AGENDA DESIGN ADVISORY PANEL MEETING

a. Development Permit Application No. DP1086 - 1100 Maughan Road

STAFF DESIGN COMMENT

DEVELOPMENT PERMIT APPLICATION NO. DP1086 – 1100 MAUGHAN ROAD

SITE PLAN - PHASE 1	
DESIGNED KAR	DESIGN REVIEW
DRAFTED KAR	DRAFTING REVIEW
PROJECT No. 3399-006	CLIENT Drawing No.
SCALE 1 : 300	PERMIT No.
REL. DRAWING No. A101	REVISION 5

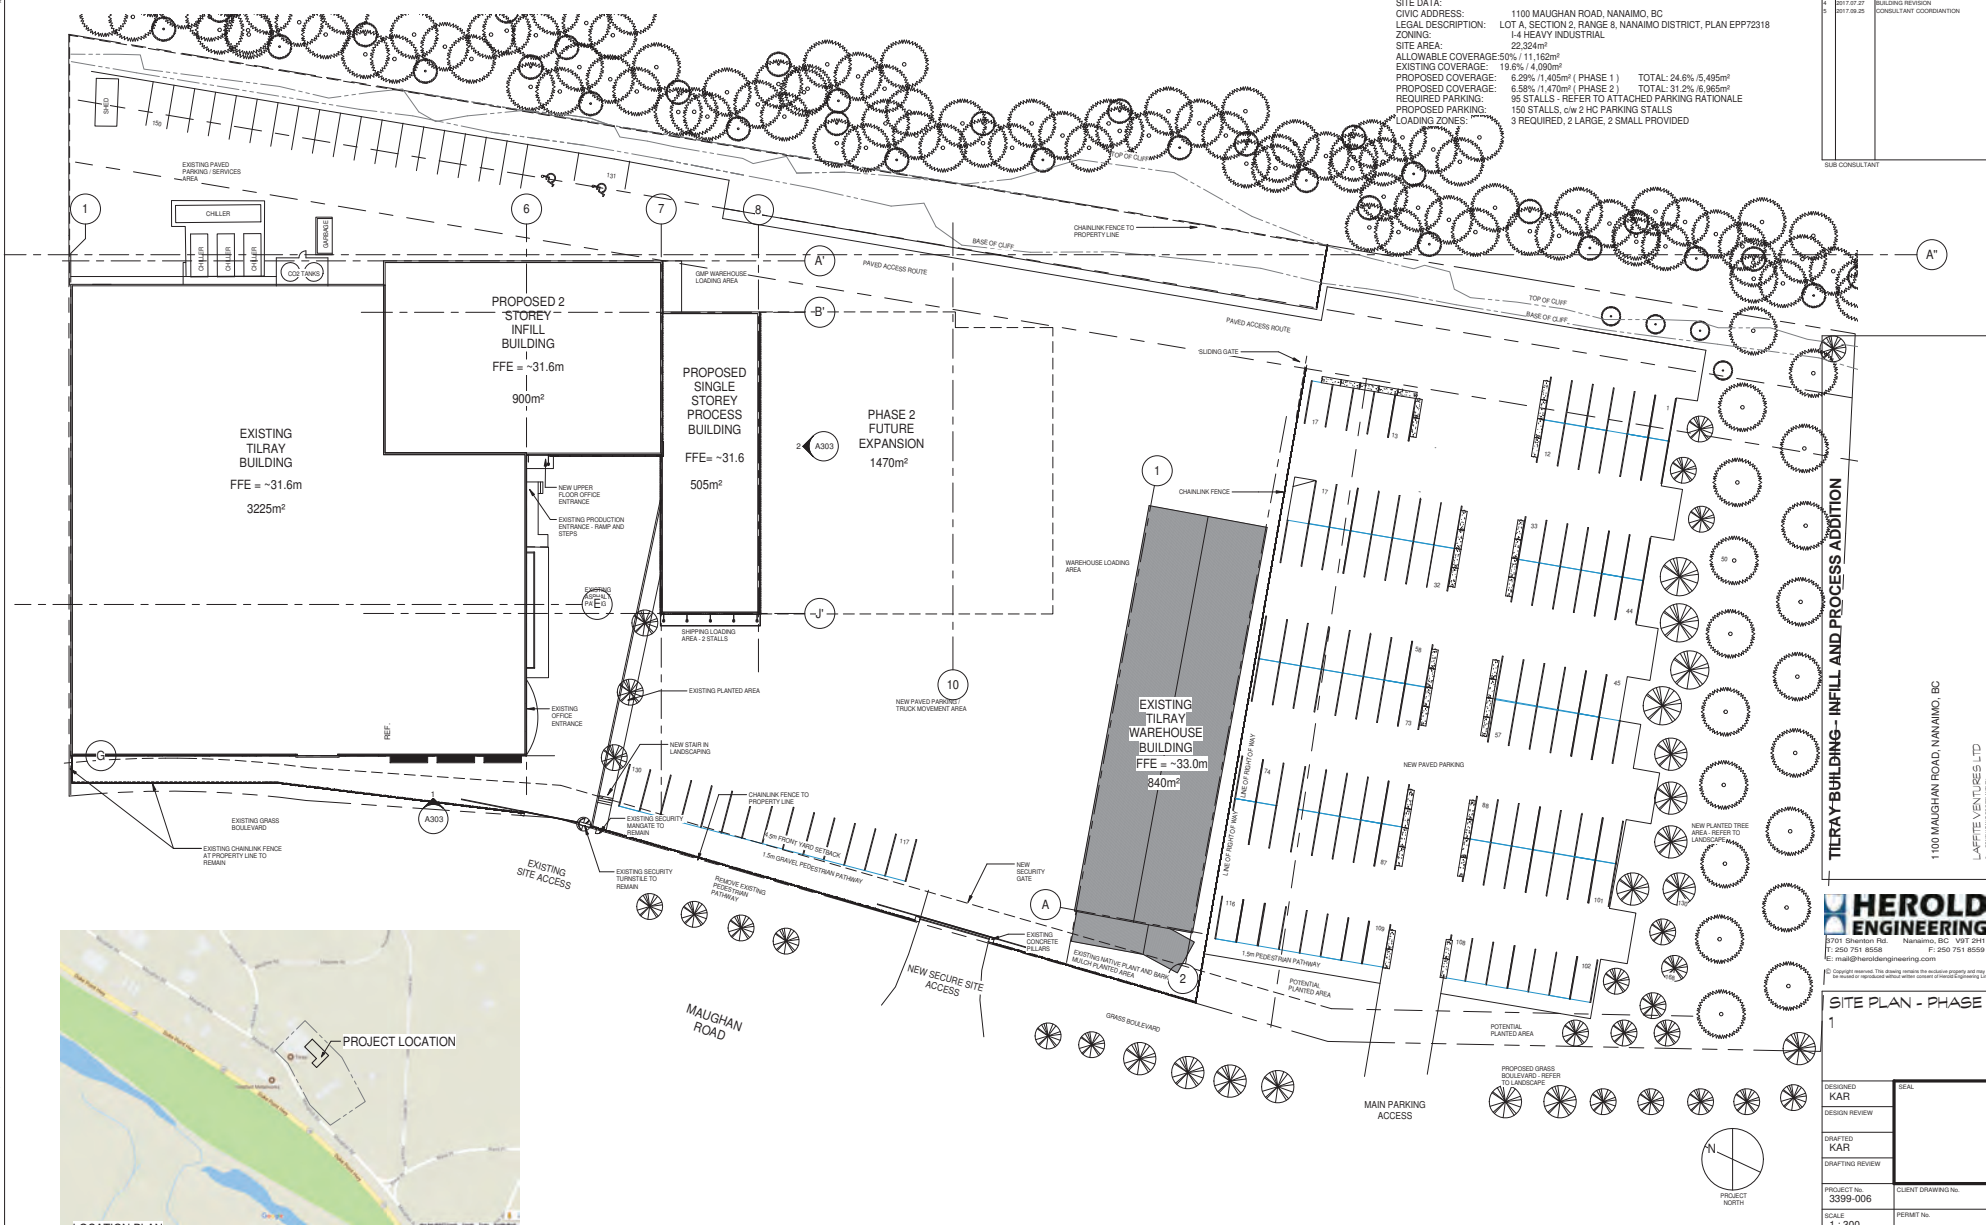
- A lighting program should be provided to address site safety concerns and for design enhancements to the building.
- The pedestrian pathway should be paved and adequately separated from the parking area.
- The landscaped strip between the main building and the parking lot should be re-designed to accommodate the pedestrian pathway across it to access the building entrance.

West Site
Planting Plan
 Scale 1:250

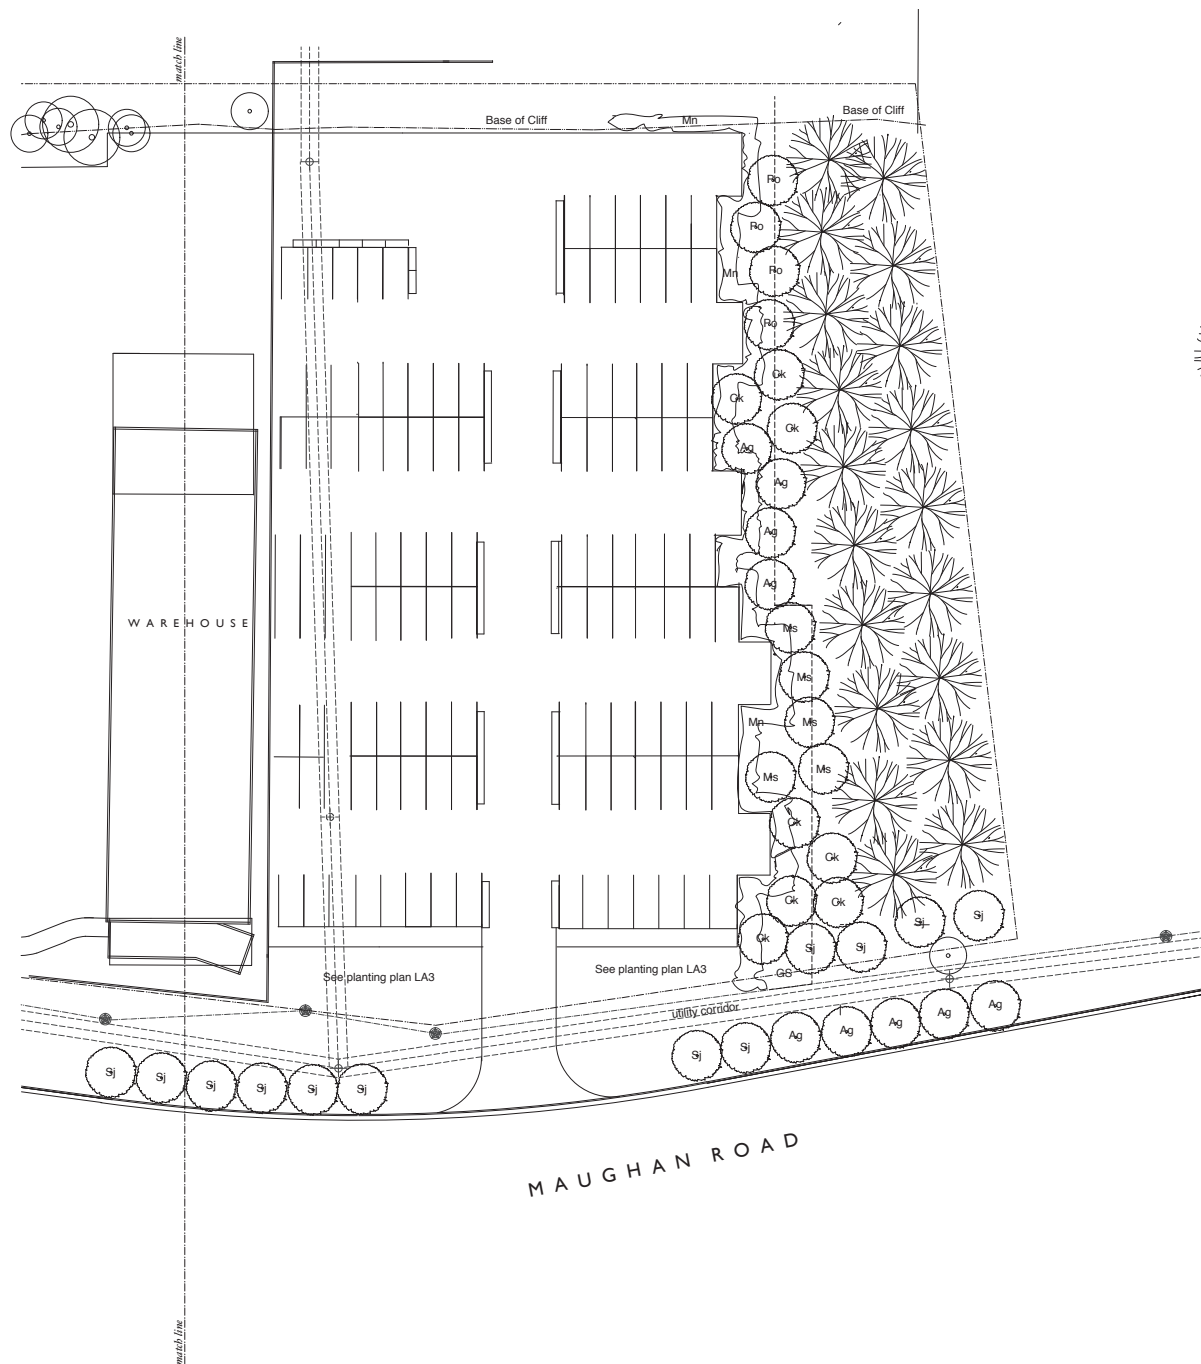
- The required landscape buffer is intended to screen parking areas and provide an aesthetically pleasing streetscape. The previously planted buffer in front of the existing pre-engineered warehouse is sparse. Staff are concerned that the proposed landscaping buffer is not of adequate density and scale.

BUILDING ELEVATIONS - PHASE 1

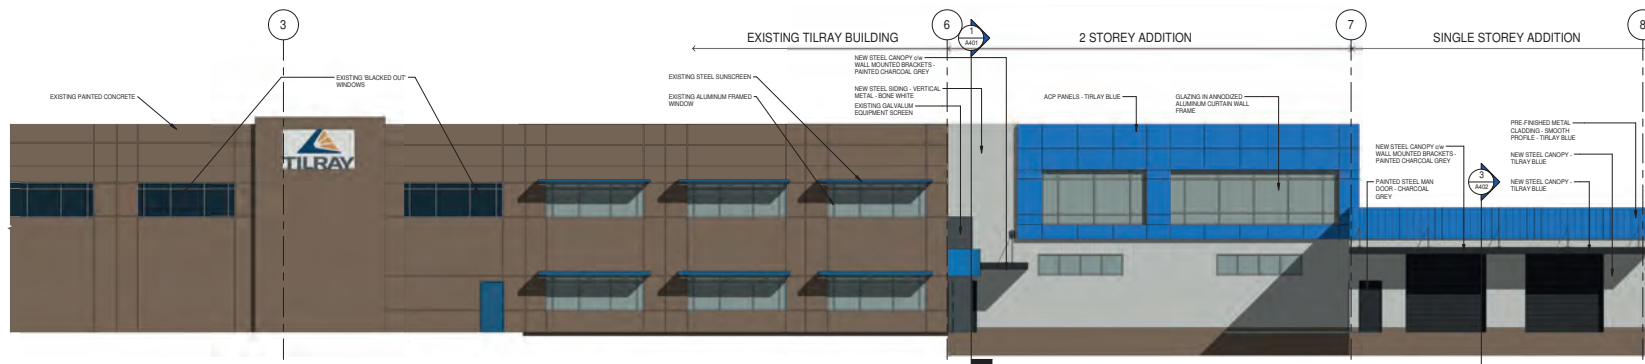
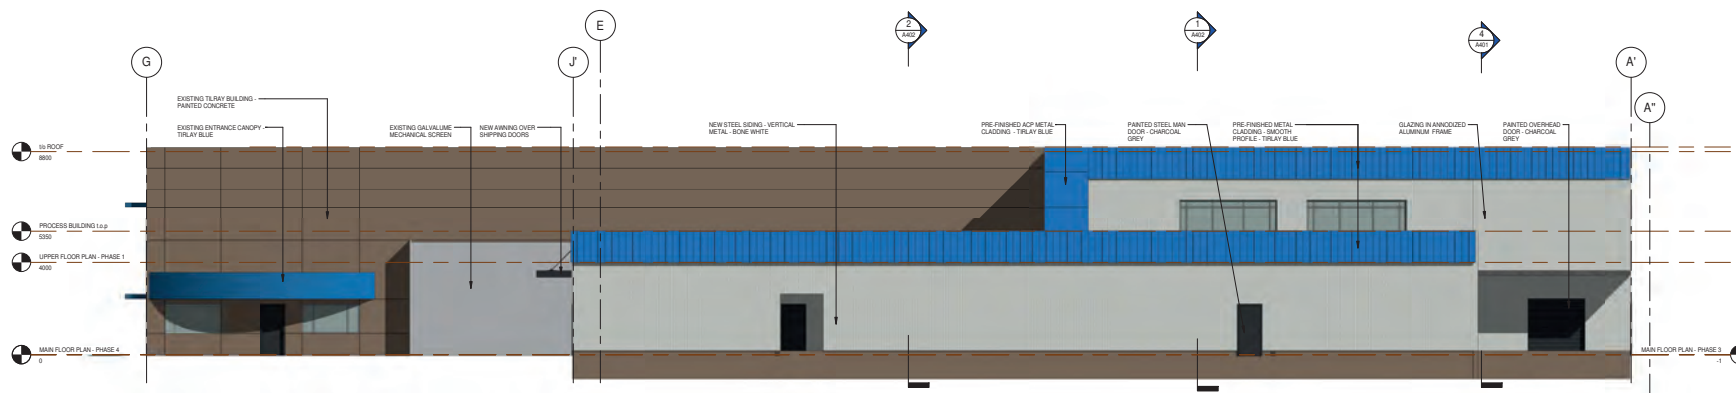
- The design of the single storey addition results in a long, uninterrupted building mass, which is not consistent with the design guidelines. While the design is utilitarian in nature to maximize design flexibility for the internal floor space, what façade improvements could be implemented to visually break up the long, linear wall face and roofline?
